DATE: 9-29-17

APPLIES TO: This service bulletin applies to certain Spartan Emergency Response Tractor Drawn Aerial Fire Apparatus built by Spartan Motors USA, Inc. between November 2004 and December 2016

CONDITION: Loose or missing suspension fasteners / cracked suspension sub-structure

CORRECTION: Addition of reinforcing plate and increase fastener size

FIG. 3-1

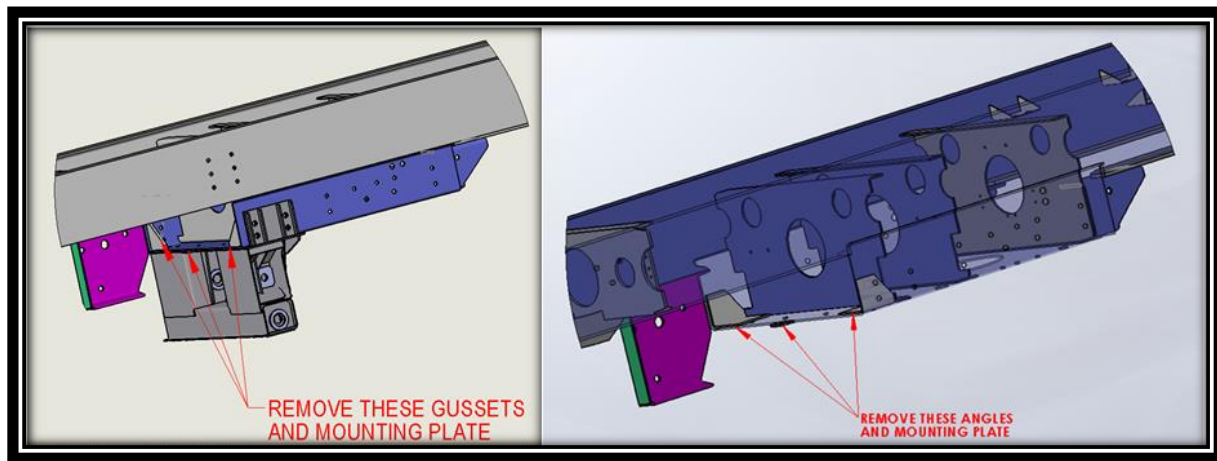
1. Remove and properly dispose of gussets or angles and mounting plate shown below. Grind area flush, prime & paint. Refer to FIG. 3-1.
 - a. Front power steering gearbox bolt may be removed and retained for access
 - b. Remove and retain two outboard 5/8" vertical bolts for access
 - c. If equipped, remove and retain for reuse AC condenser and filter from current mounting locations

NOTE: If crack exist in suspension mounting structure, grind out crack, and re-weld before step 2.

FIG. 4-1

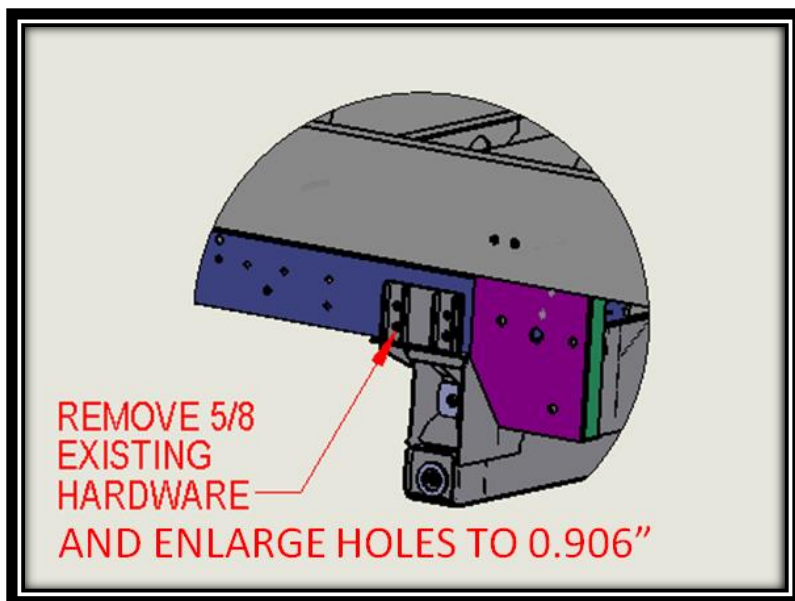
2. Remove and properly dispose of existing 5/8" hardware shown below. Enlarge holes for suspension hanger and suspension mount to .906 dia. Refer to FIG. 4-1.

NOTE: Clear any hoses/wiring inside of suspension mount before drilling

FIG. 4-2

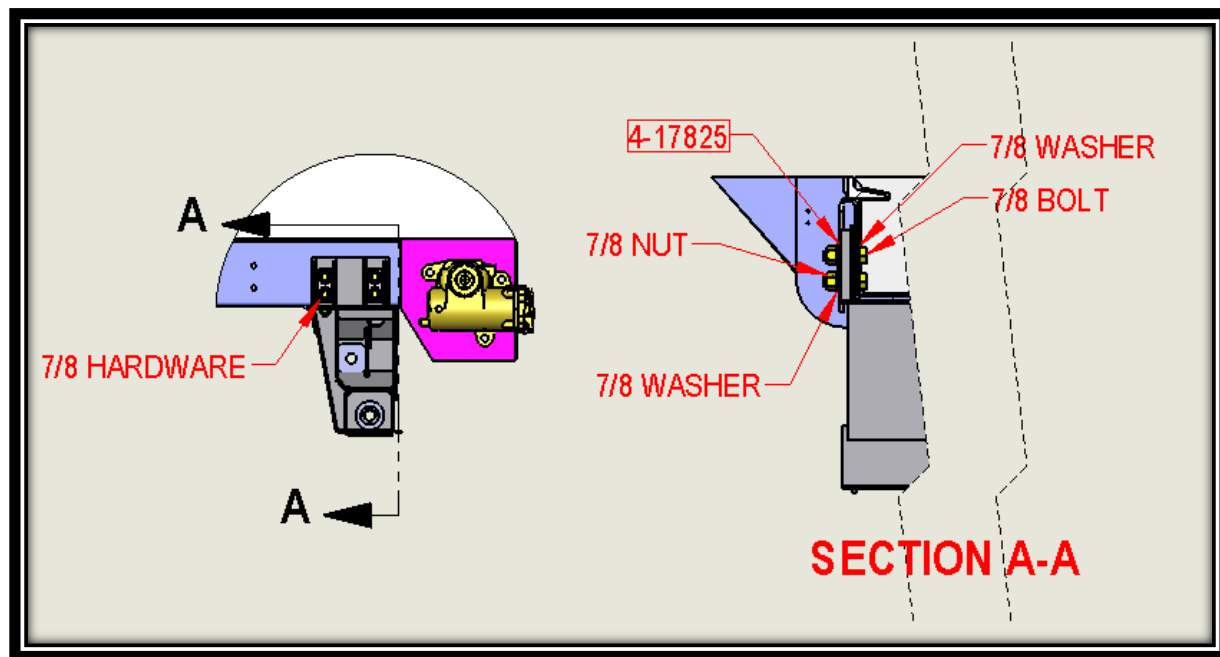
3. Install 7/8 bolt, flat washer, from inside of suspension mount & thru Ridewell suspension hanger. Install spacer 4-17825, with bevels facing Ridewell suspension hanger, flat washer & hex nut. Torque to 505 lbf-ft. (4) places. Refer to FIG. 4-2.

FIG. 5-1

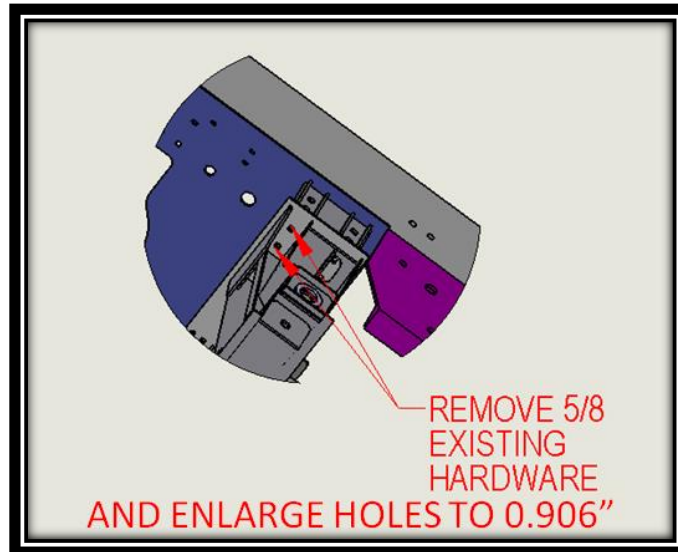
4. Remove and properly dispose of existing 5/8" hardware shown below. Enlarge holes for suspension hanger and suspension mount .781 dia. Refer to FIG. 5-1.

NOTE: Clear any hoses/wiring inside of suspension mount before drilling

FIG. 5-2

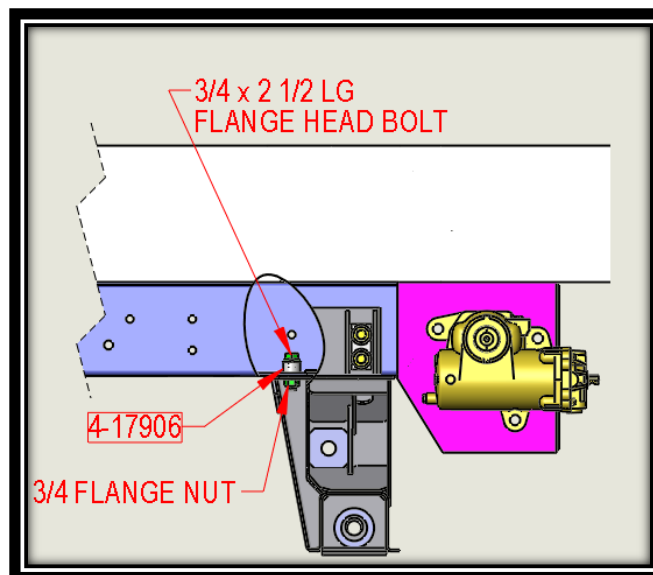
5. Install 3/4 x 2 1/2 lg flange head bolt, spacer 4-17906, from inside of suspension mount & thru Ridewell suspension hanger. Install 3/4 flange nuts torquing inside to out, to 375 lbf-ft. (2) places Refer to FIG. 5-2

FIG. 6-1

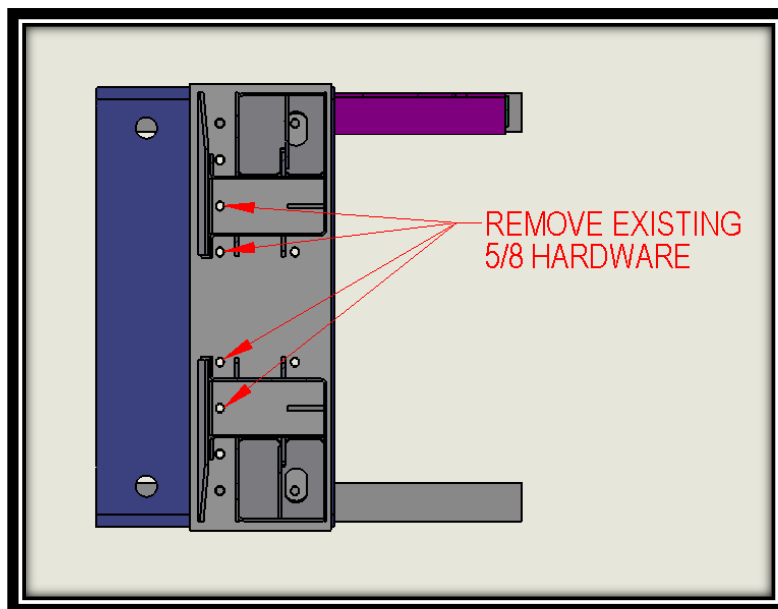
6. Repeat steps 2-5 on opposite side.
7. Remove and properly dispose of existing 5/8" hardware shown below. Refer to FIG. 6-1.

FIG. 6-2

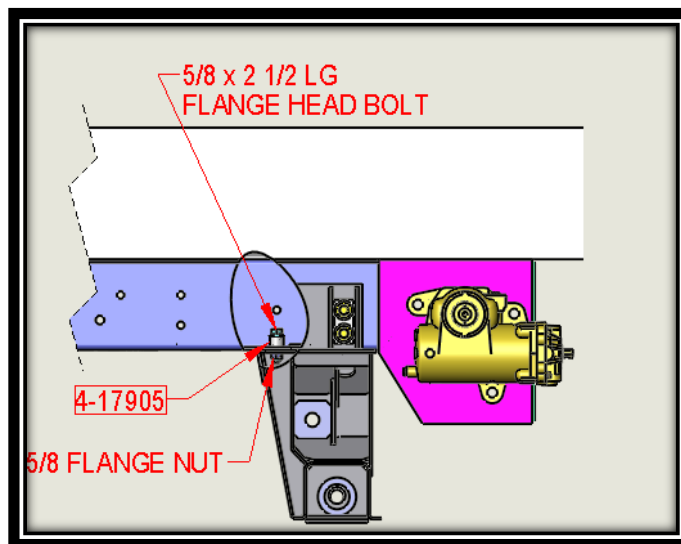
8. Install 5/8 x 2 1/2 lg flange head bolt, spacer 4-17905, from inside of suspension mount & thru Ridewell suspension hanger. Install 5/8 flange nut torquing from inside to out, to 216 lbf-ft. (4) places. Refer to FIG. 6-2.

FIG. 7-1

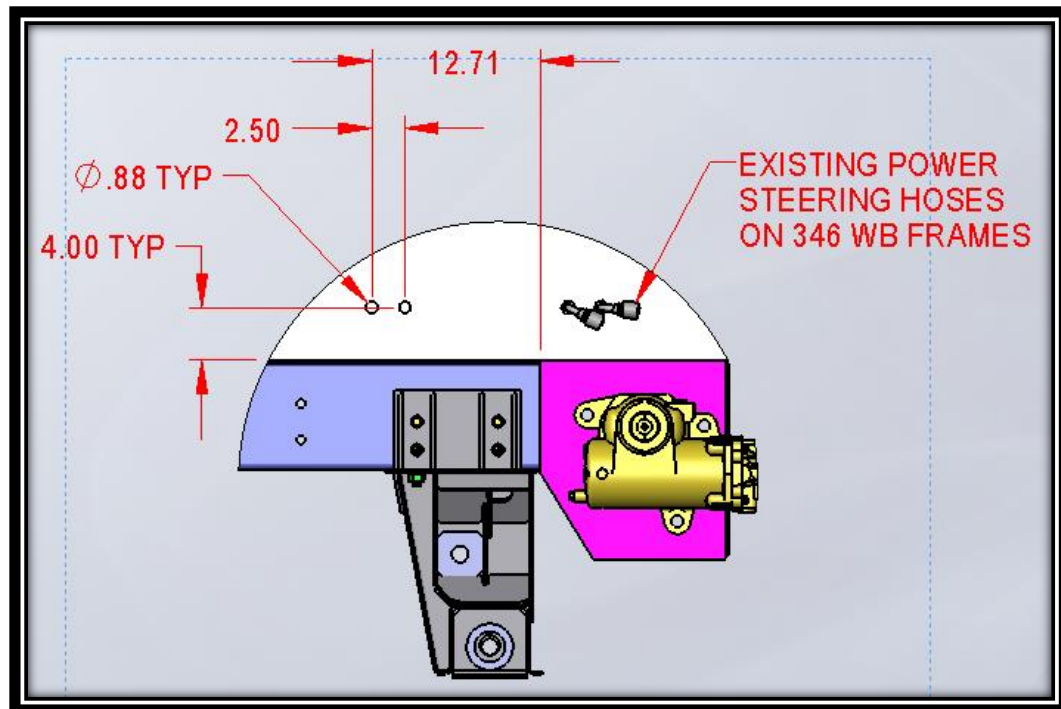
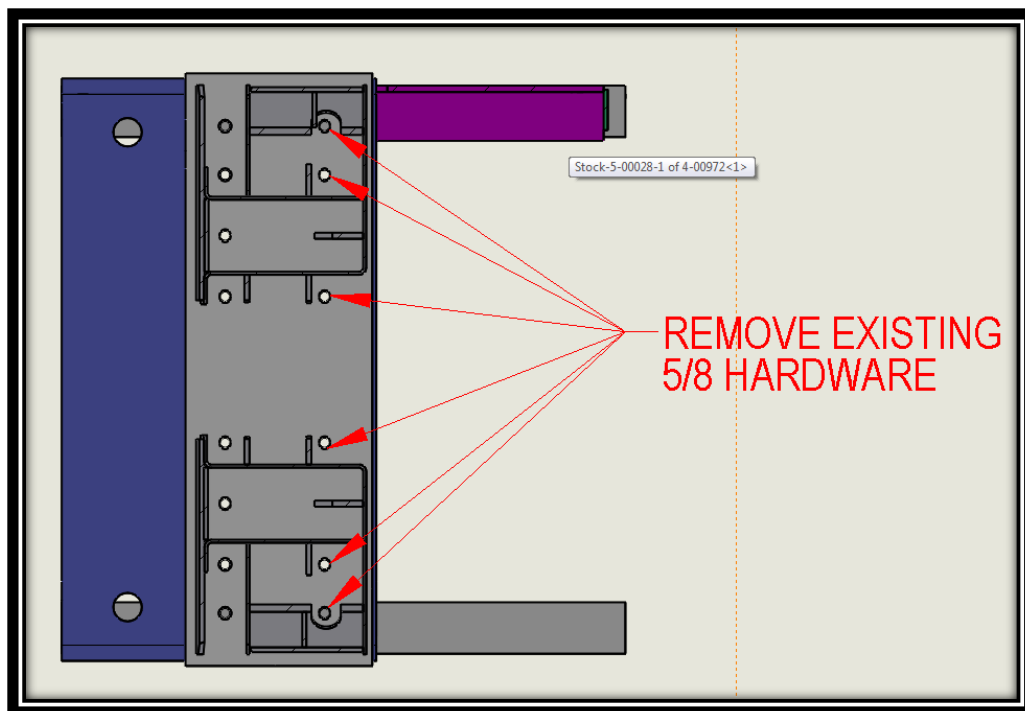
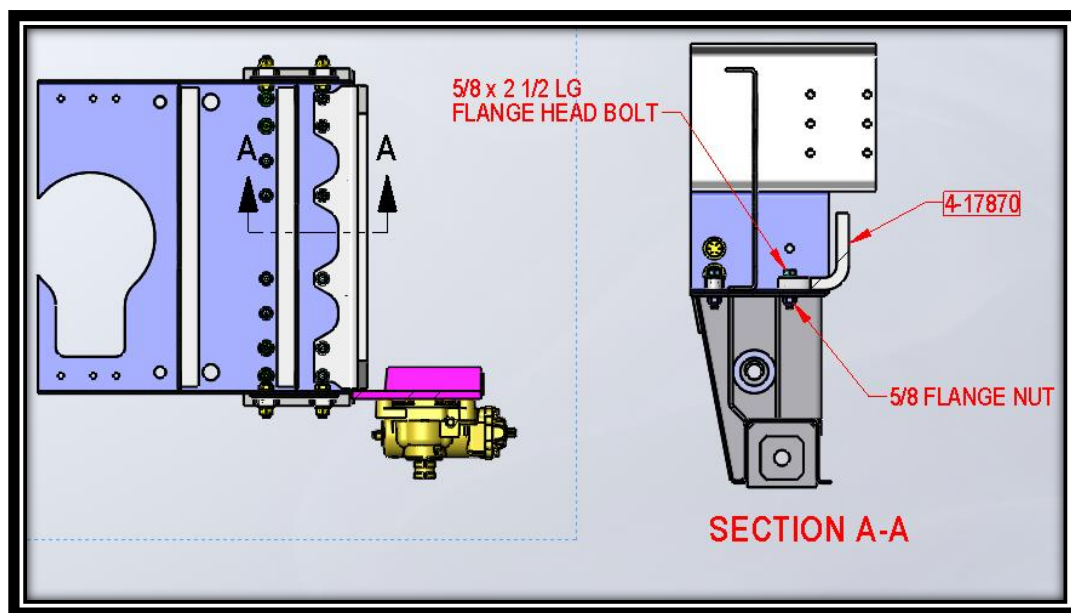
9. For units with a 346" wheel base and power steering lines located forward of the steering gear centerline use kit 8-00148. Relocate bulkhead fittings as shown below. Refer to FIG. 7-1.
10. Disconnect power steering hoses from bulkhead and steering gear fittings, seal off to insure no contaminants are introduced into hoses or steering gear. Relocate existing hoses & bulkhead fittings in new locations shown in FIG. 7.1 & tighten.

FIG. 9-1

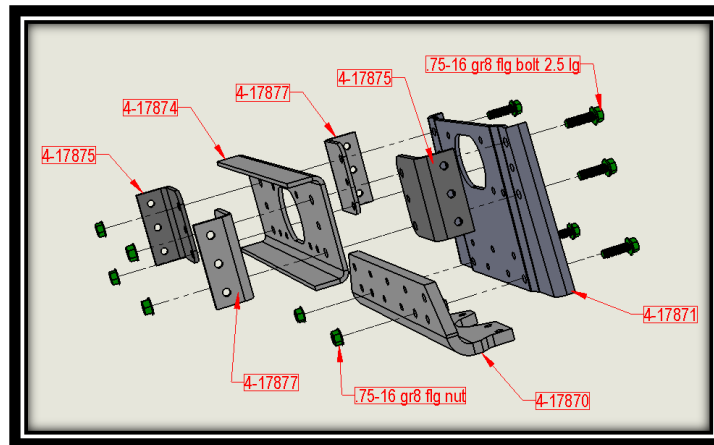
15. P-clamps securing wiring on both sides of frame rail may be temporarily removed to get wiring out of way.
16. Install parts shown below in frame and tighten, but do not torque. Use angle brackets 4-17875 & 4-17877 as a fixture to locate and mark (12) .656 dia holes on frame rail. Refer to FIG. 9-1.

FIG. 9-2

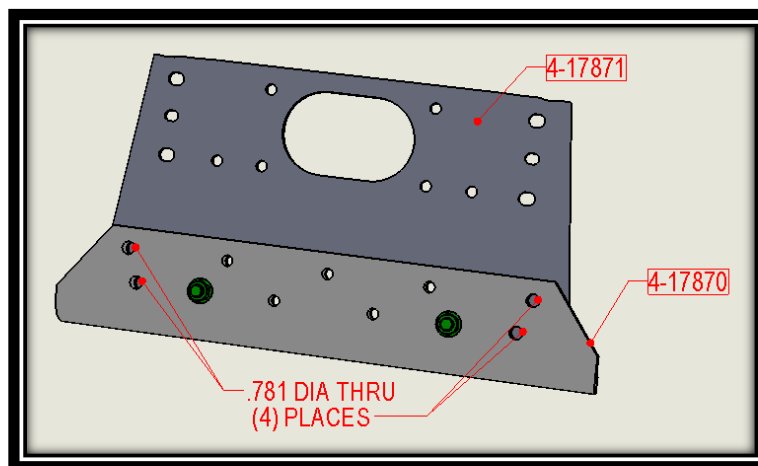
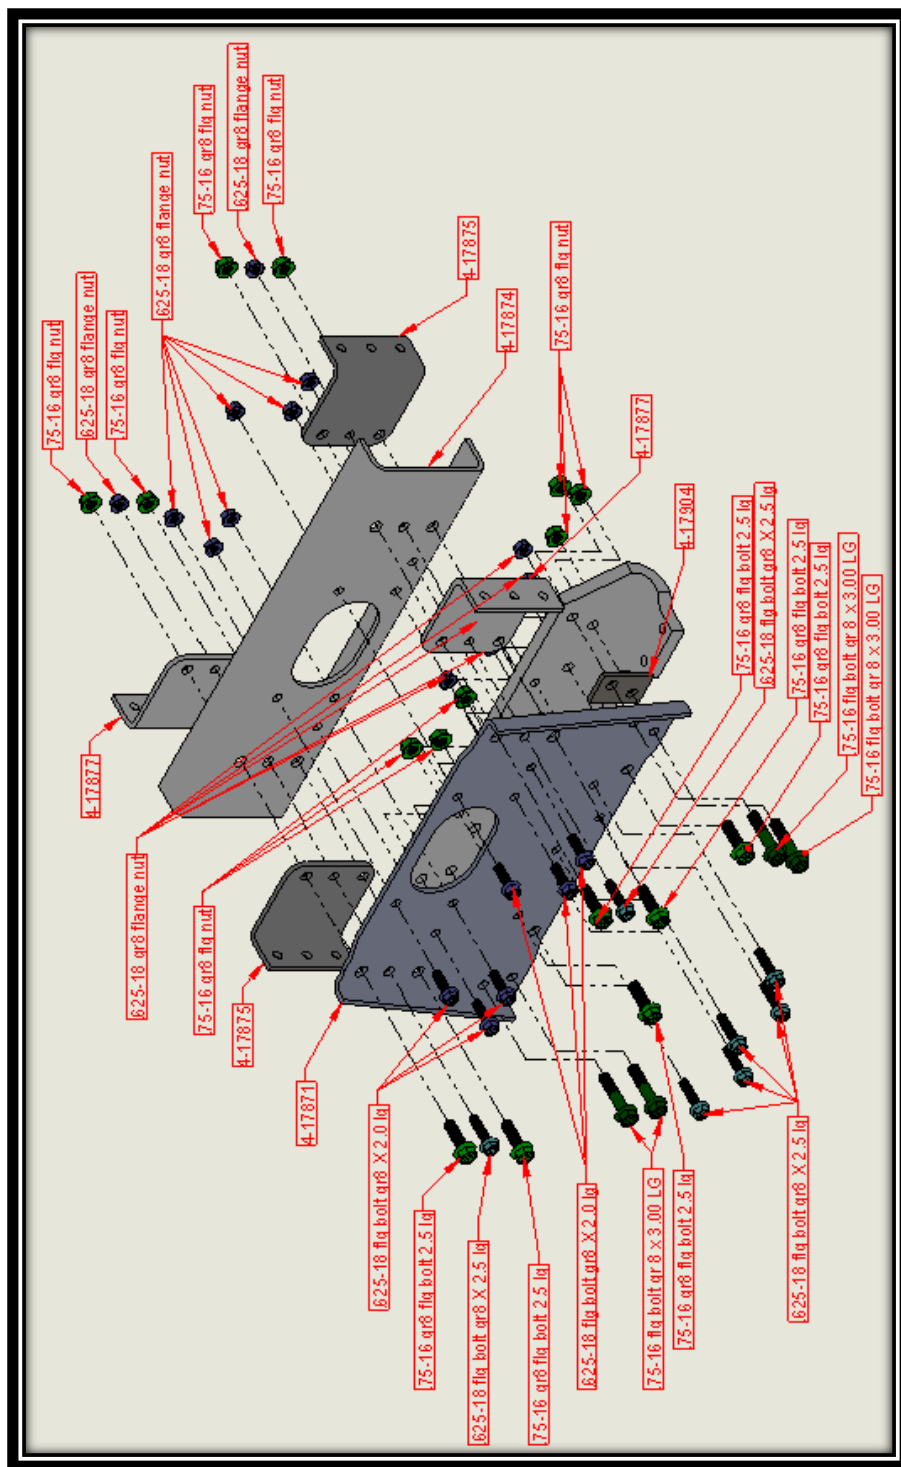
17. Using 4-17870 as a template, drill (4) .781 dia thru in 4-17871.
18. Remove and retain for reuse parts installed in step 16 & drill (12) .656 dia holes in frame rails. Grind area prime & paint. Refer to FIG. 9-2.

FIG. 11-1

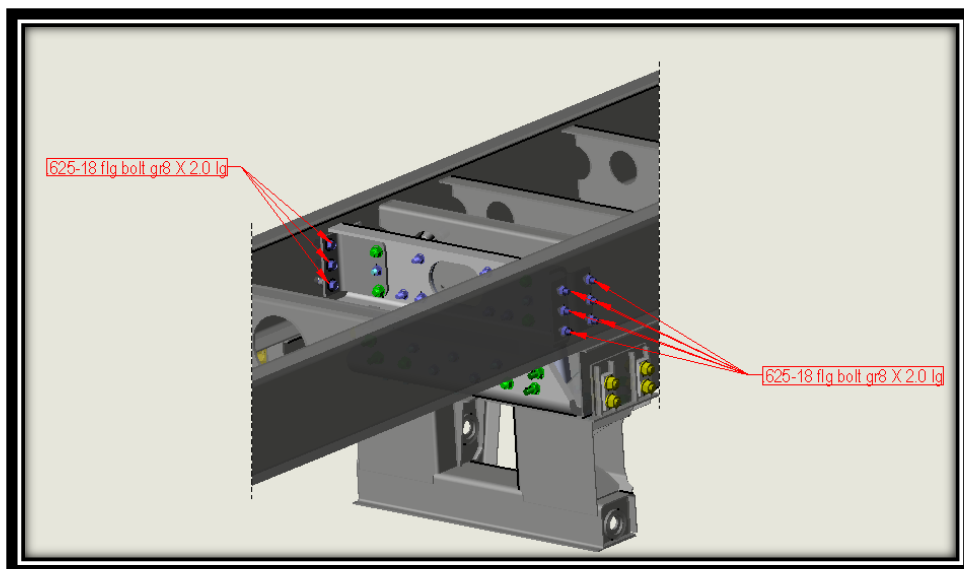
20. Install (12) 5/8-16 x 2.0 lg bolts thru angle mounting brackets 4-17875 & 4-17877, the TDA frame and 5/8 flange nuts. Loosely fasten hardware. Refer to FIG. 11-1.

FIG. 11-2

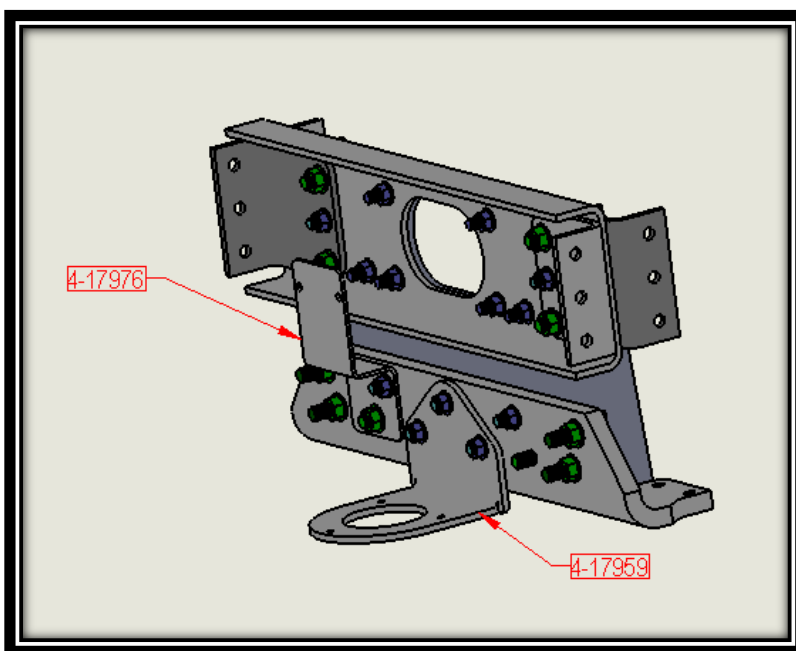
21. If equipped, install AC brackets 4-17959 & 4-17976 as show. Refer to FIG. 11-2.

FIG. 12-1

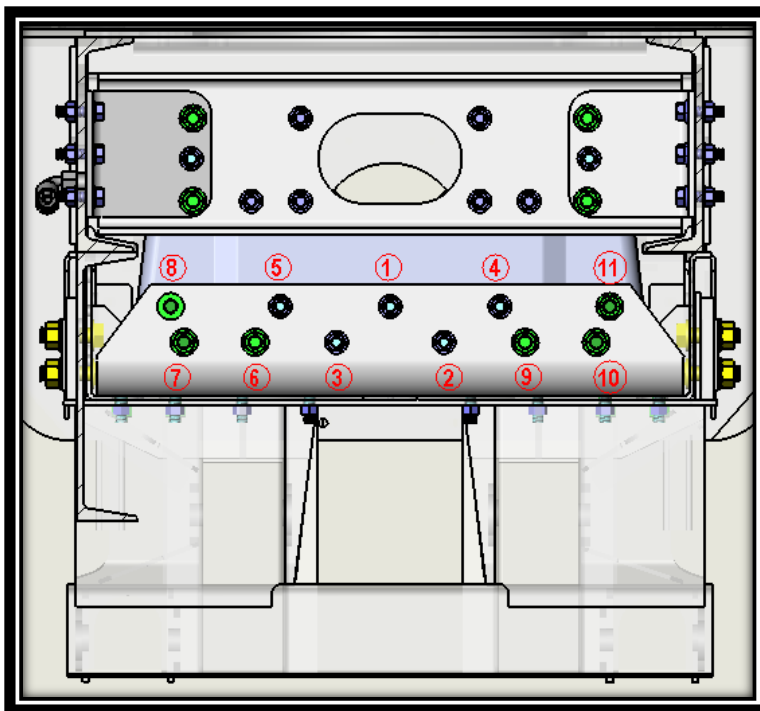
22. Torque lower hardware in order shown below. 5/8 hardware to be torqued to 216 lbf-ft.lb.
3/4 hardware to be torqued to 375 lbf-ft. Refer to FIG. 12-1.

FIG. 12-2

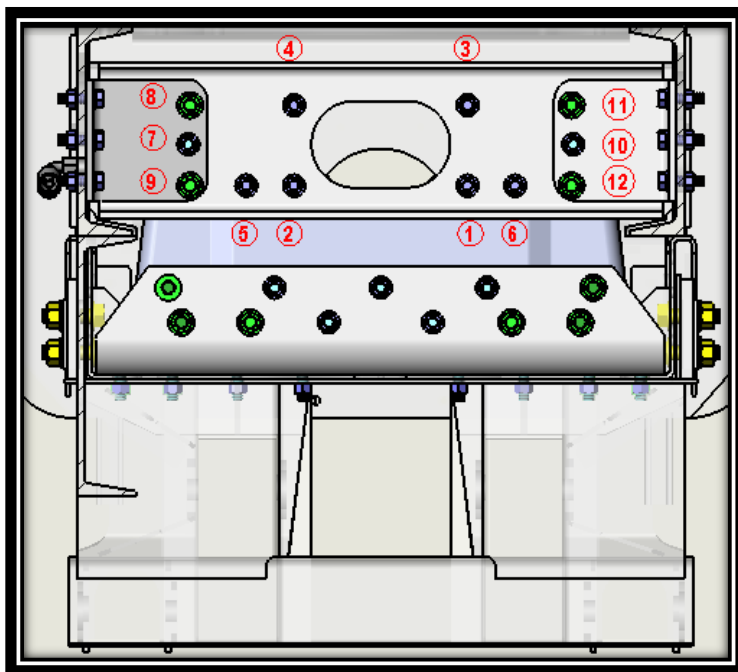
23. Torque upper hardware in order shown below. 5/8 hardware to be torqued to 216 lbf-ft.lb.
3/4 hardware to be torqued to 375 lbf-ft. Refer to FIG. 12-2.

FIG. 13-1

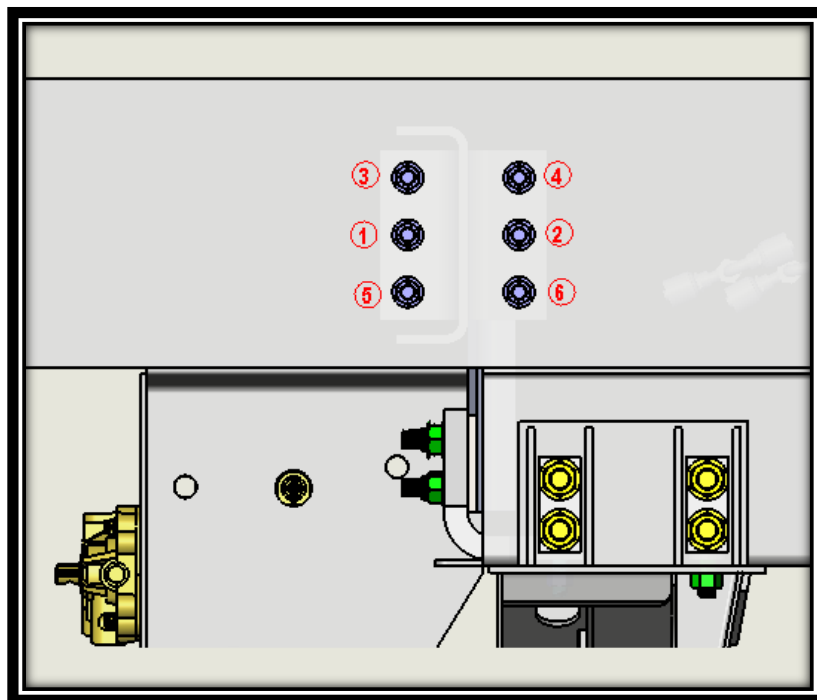
24. Torque side hardware in order shown below. 5/8 hardware to be torqued to 216 lbf-ft.
Refer to FIG. 13-1.

Left hand side same sequence as shown
